## ADDENDUM TO THE CONTRACT

### JUNEAU DOUGLAS TREATMENT PLANT ELECTRICAL UPGRADES

Contract No. BE21-141

**ADDENDUM NO.:** ONE

DRAWING #:  
**E-12**  
 SHEET  
**12** OF **21**

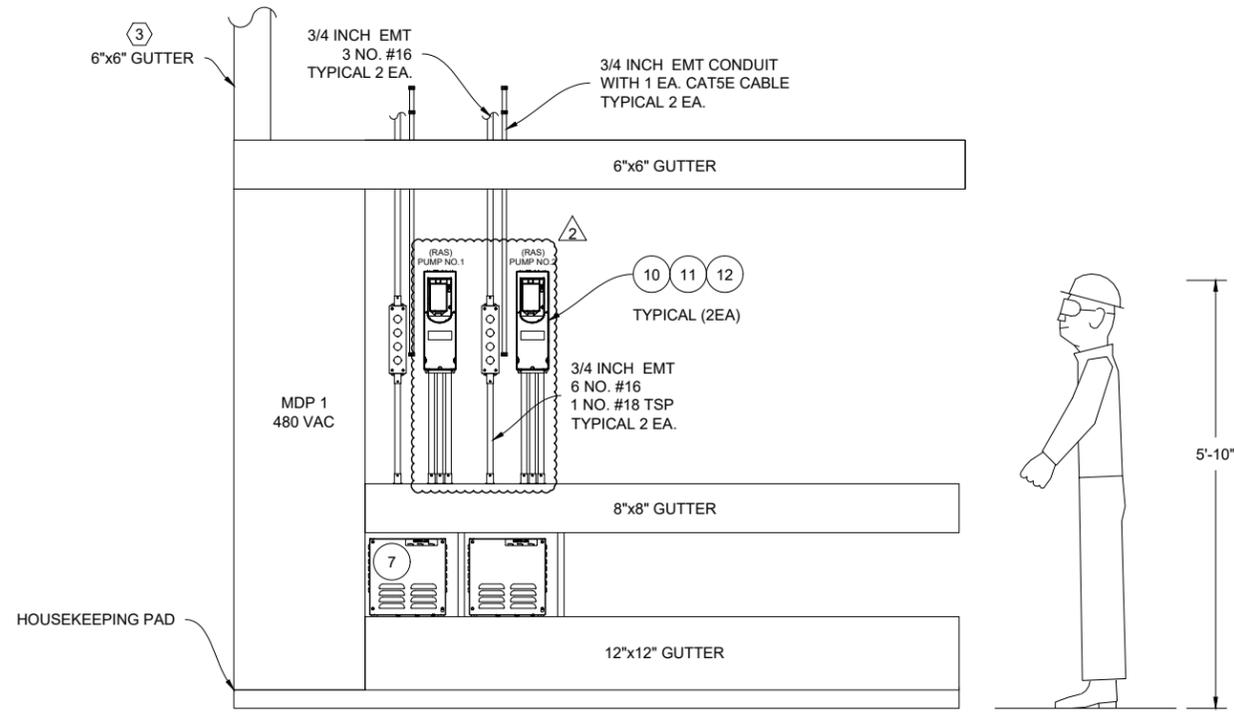
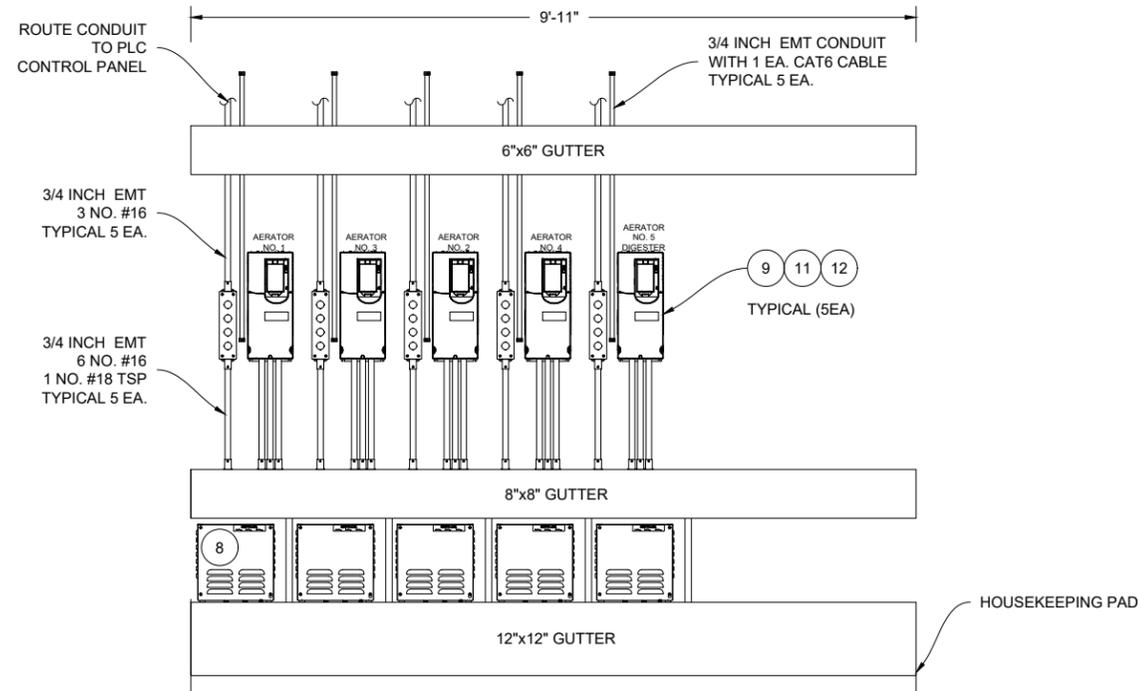
- Item No. 2 SHEET E-12 – Electrical Gear Elevated View Section 2 (New)  
**Delete and replace** SHEET E-12 **with** the attached SHEET E-12  
Revisions include:  
-Change the RAS Pump VFD from 15 HP to 25 HP  
-Change the RAS Pump Line Reactor from 15 HP to 25 HP.

- FIELD VERIFY DIMENSIONS.
- INSTALL 6 INCH GUTTER SO THAT FRONT COVER IS FLUSH WITH FRONT OF 8 INCH GUTTER TO PROVIDE PATH FOR CONDUITS. INSTALL STRUT AS NECESSARY.
- INSTALL VERTICAL GUTTER ON BOTH SIDES OF WALL. ROUTE EXISTING CONDUITS INTO GUTTER LOCATED IN HALLWAY. PROVIDE RACEWAY BETWEEN GUTTERS FOR EXISTING CIRCUITS.
- RAS PUMP 1 AND 2 VFDS SIZED AT 25HP.

DRAWING #:  
**E-13**  
 SHEET  
**13 OF 21**

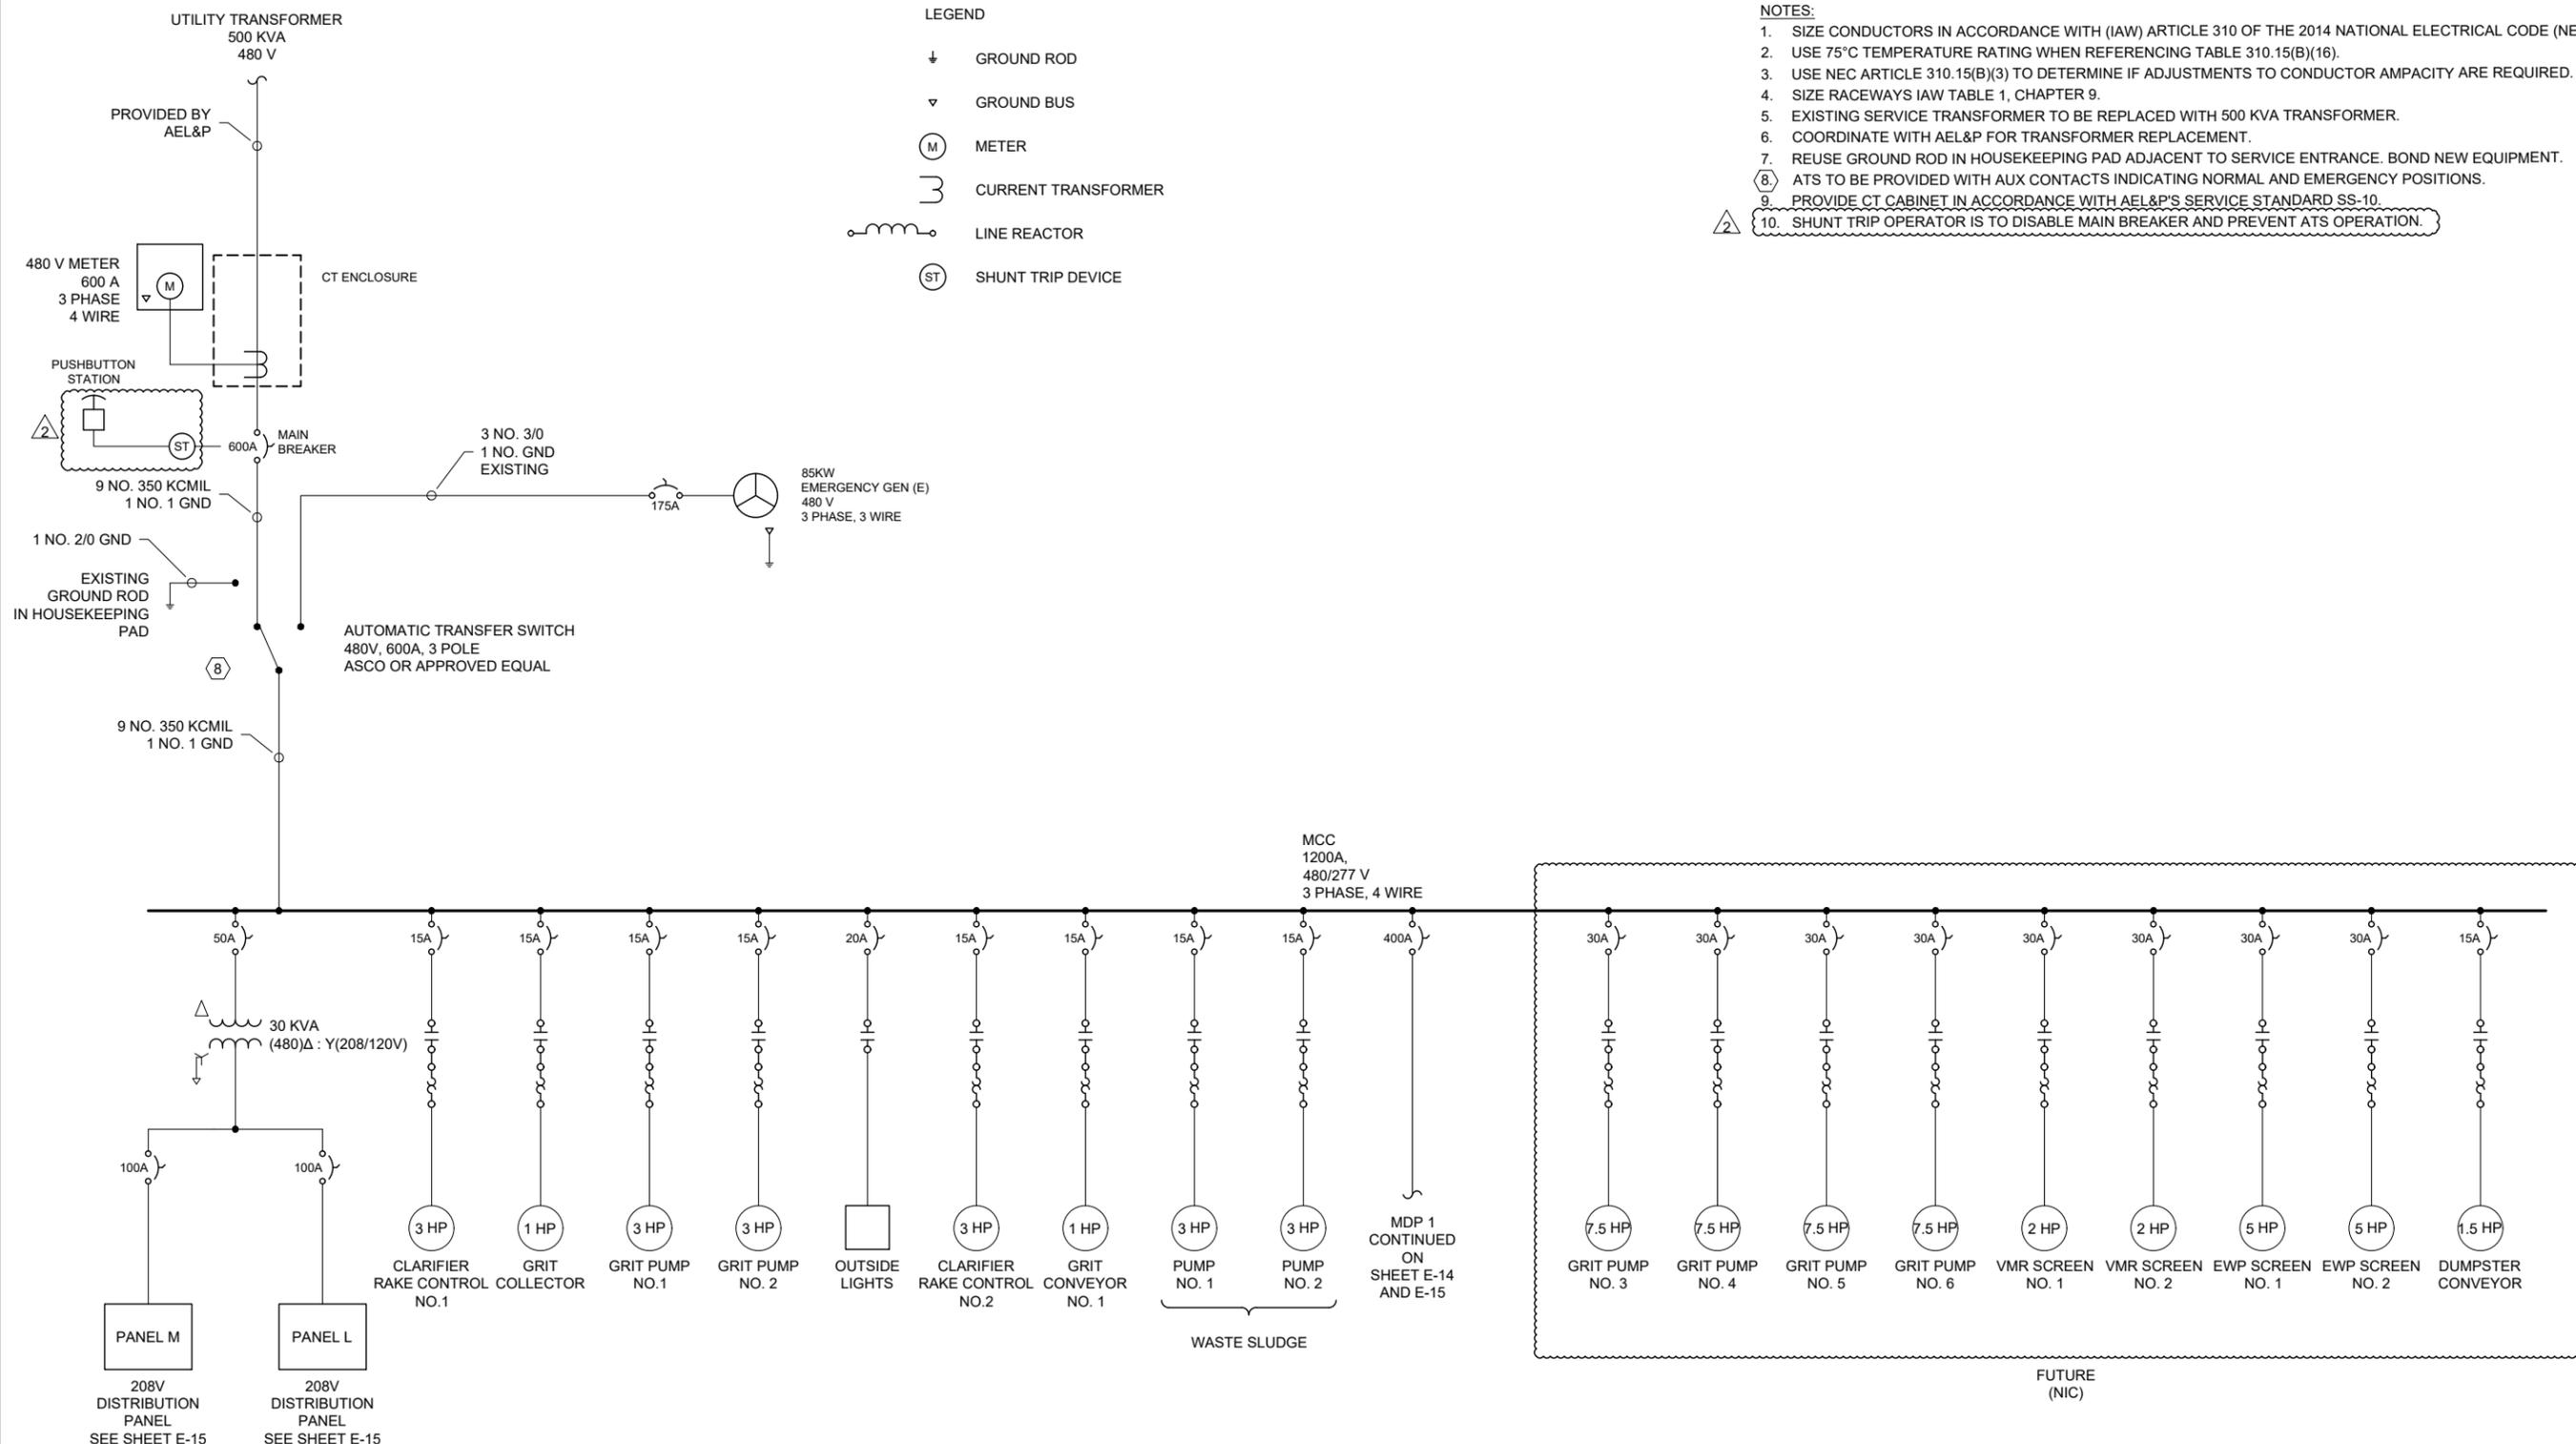
- Item No. 3 SHEET E-13 – One Line (New)  
**Delete and replace** SHEET E-13 **with** the attached SHEET E-13  
Revision includes:  
-Shunt trip operator is to disable main breaker and prevent ATS from operating.

- NOTES:**
1. SIZE CONDUCTORS IN ACCORDANCE WITH (IAW) ARTICLE 310 OF THE 2014 NATIONAL ELECTRICAL CODE (NEC).
  2. USE 75°C TEMPERATURE RATING WHEN REFERENCING TABLE 310.15(B)(16).
  3. USE NEC ARTICLE 310.15(B)(3) TO DETERMINE IF ADJUSTMENTS TO CONDUCTOR AMPACITY ARE REQUIRED.
  4. SIZE RACEWAYS IAW TABLE 1, CHAPTER 9.
  5. EXISTING SERVICE TRANSFORMER TO BE REPLACED WITH 500 KVA TRANSFORMER.
  6. COORDINATE WITH AEL&P FOR TRANSFORMER REPLACEMENT.
  7. REUSE GROUND ROD IN HOUSEKEEPING PAD ADJACENT TO SERVICE ENTRANCE. BOND NEW EQUIPMENT.
  8. ATS TO BE PROVIDED WITH AUX CONTACTS INDICATING NORMAL AND EMERGENCY POSITIONS.
  9. PROVIDE CT CABINET IN ACCORDANCE WITH AEL&P'S SERVICE STANDARD SS-10.
  10. SHUNT TRIP OPERATOR IS TO DISABLE MAIN BREAKER AND PREVENT ATS OPERATION.

DRAWING #:  
**E-14**  
SHEET  
**14** OF **21**

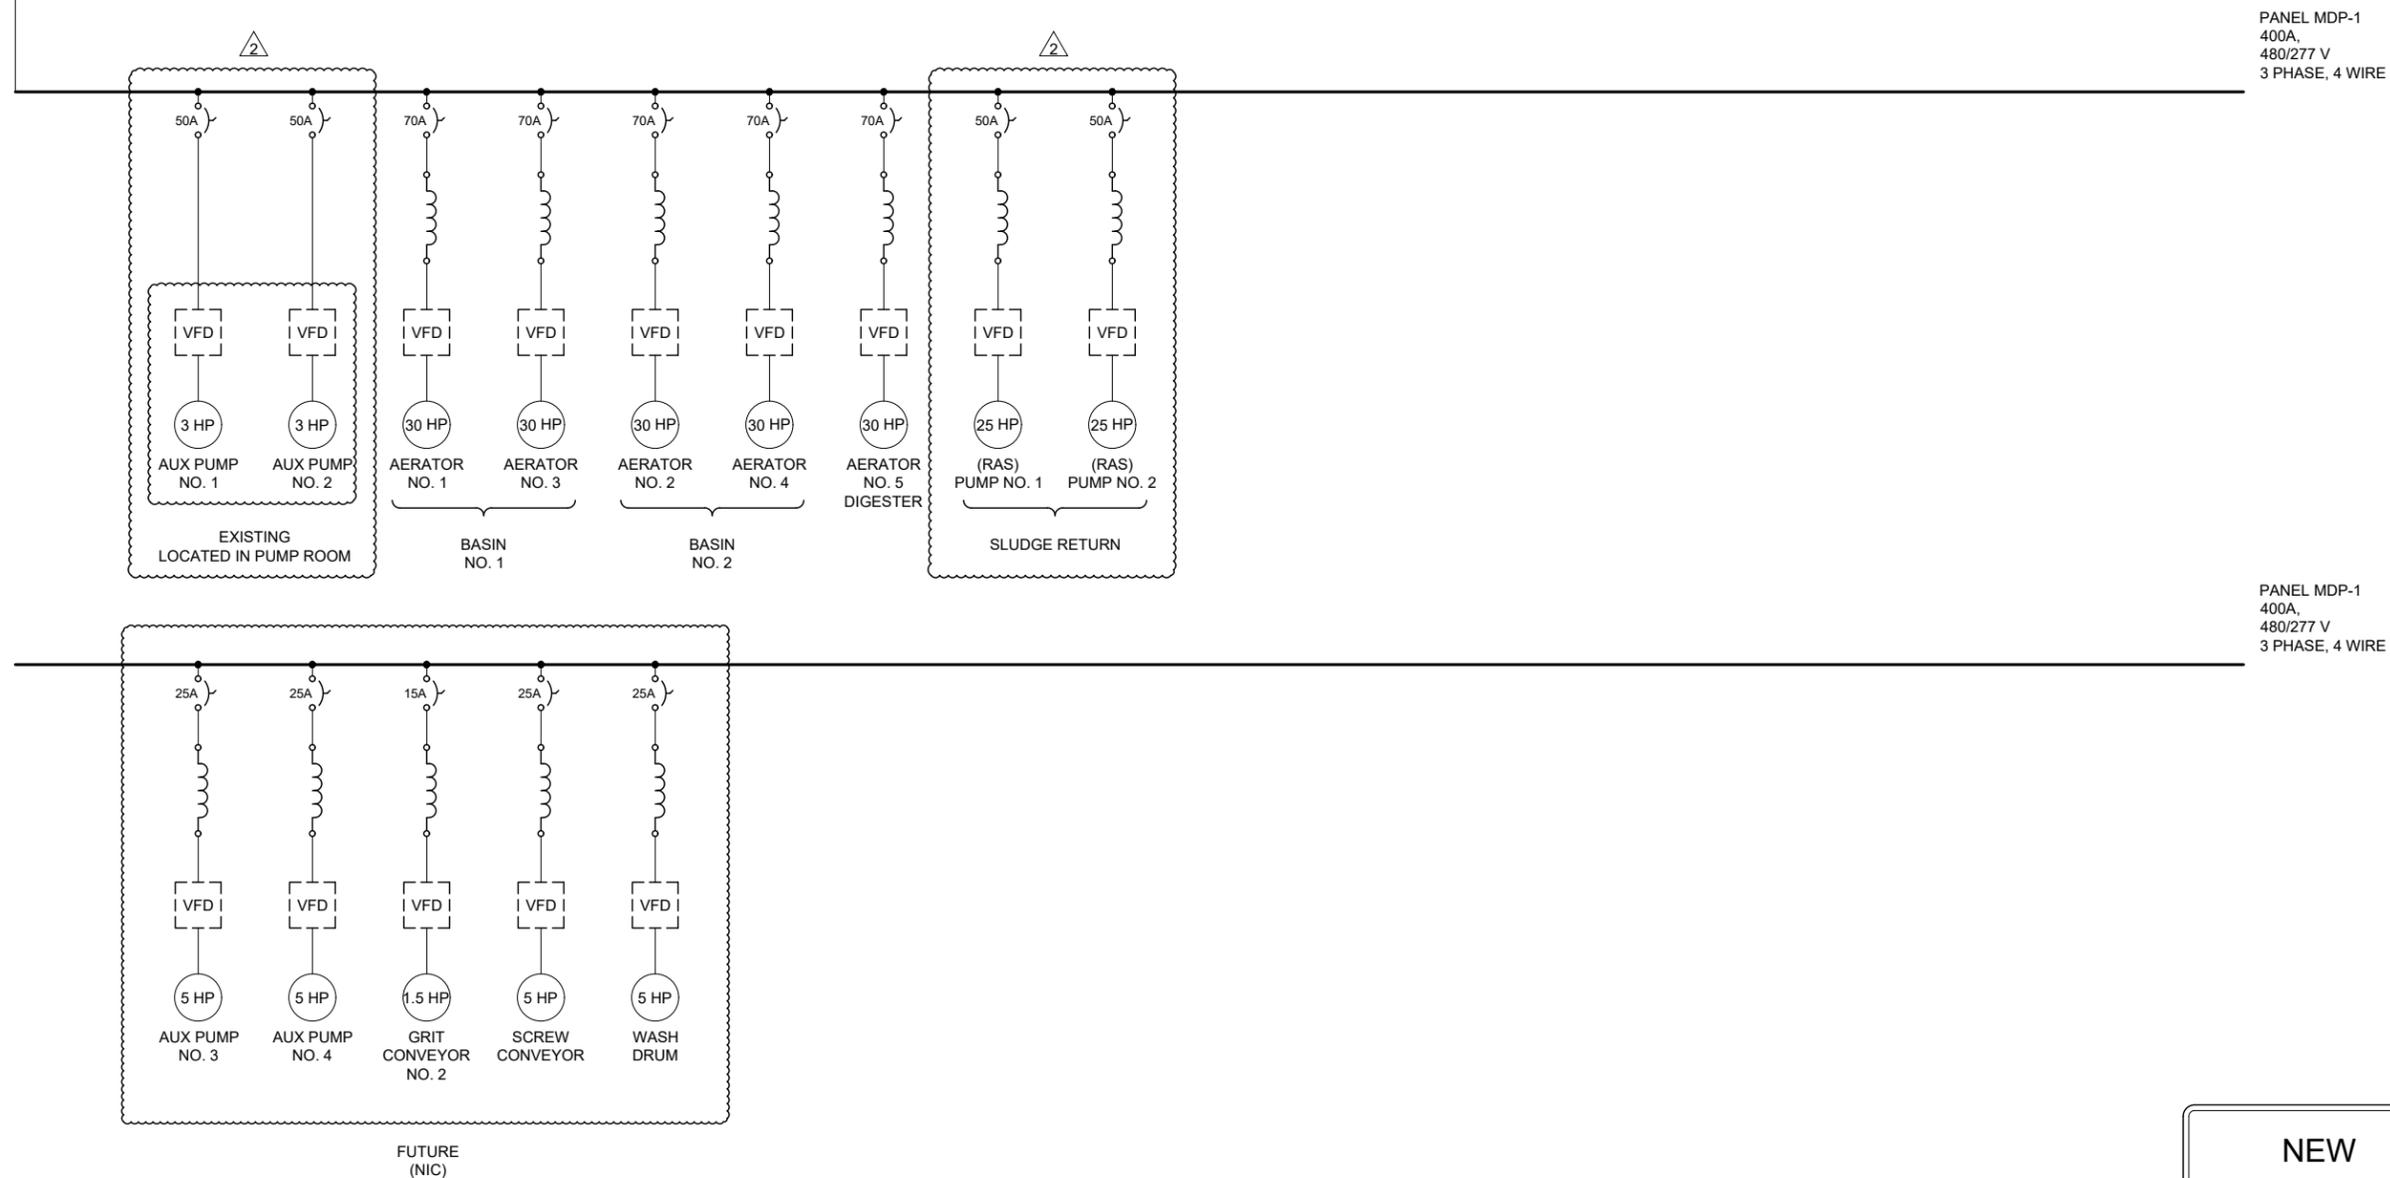
- Item No. 4 SHEET E-14 – MDP-1 One Line (New)  
**Delete and replace** SHEET E-14 **with** the attached SHEET E-14  
Revisions include:  
-Change motor size on Aux Pump 1 and 2 to 25HP.  
-Change circuit breaker size on Aux Pump 1 and 2 to 50A.  
-Aux Pump VFDs are to remain undisturbed and are to be fed from new circuit breakers.  
-Change motor/VFD size on RAS Pump 1 and 2 to 25HP.  
-Change circuit breaker size on RAS pump 1 and 2 to 50A.

1. FOR FULL PANEL SCHEDULE SEE SHEET E-15
2. AUX PUMP NO.1 AND NO.2 WILL REMAIN UNDISTURBED.
3. AUX PUMP VFDS WILL REMAIN INPLACE LOCATED IN PUMP ROOM, CIRCUIT PROTECTION SIZED AT 25HP.
4. NEW RAS PUMP VFDS AND CIRCUIT PROTECTION SIZED AT 25HP.
